[Docket No. 2001-SW-67-AD; Amendment 39-12710; AD 2002-08-03]

Airworthiness Directives; Enstrom Helicopter Corporation Model F-28, F-28A, F-28C, F-28F, 280, 280C, 280F, and 280FX Helicopters

ACTION: Final rule; request for comments.

Figure 1. Main Rotor Shaft Inspection

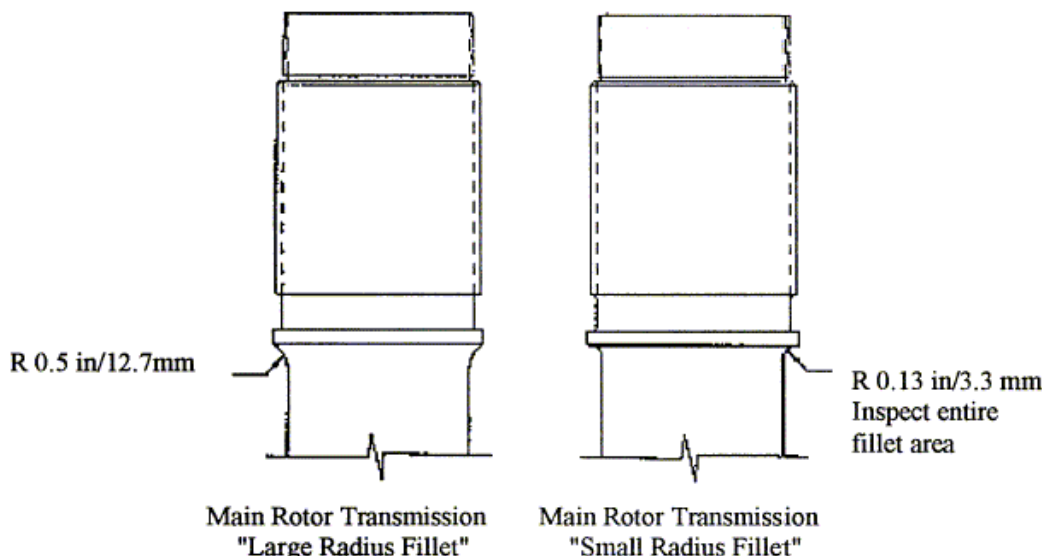
Since the issuance of AD 2001-22-01, Amendment 39-12479, the FAA received a comment that the AD should have cited additional part numbers (part number (P/N) 28-13101-3 and P/N 28-13101-3-R) in Table 1 of the AD. Further, Figure 1 of AD 2001-22-01 contained an error - "2.7mm" is now corrected to state "12.7mm". This AD also corrects another part number and other minor typographical errors. Also, since the issuance of the previous AD, the manufacturer has revised its service information and issued Enstrom Helicopter Corporation Service Directive Bulletin No. 0094, Revision 2, dated February 15, 2002.

(a) Before further flight, determine the part number (P/N) of the main rotor transmission (transmission) and the radius of the upper fillet of the shaft (as shown in the following Figure 1):

(2) If the installed transmission is P/N 28-13101-1 or -1-R, or P/N 28-13101-3 or -3-R, and has a small radius shaft, before further flight and thereafter at intervals not to exceed 25 hours TIS, visually inspect each transmission for a crack in the shaft upper fillet using a 10X or higher magnifying glass.

(i) Dye-penetrant inspect the shaft upper fillet for a crack, a nick, or a scratch.

(ii) Polish out nicks or scratches less than 0.005-inch deep.

(iii) If the shaft is cracked or has a nick or scratch 0.005 inch or more deep, replace the transmission with an airworthy transmission having a large radius shaft fillet before further flight.
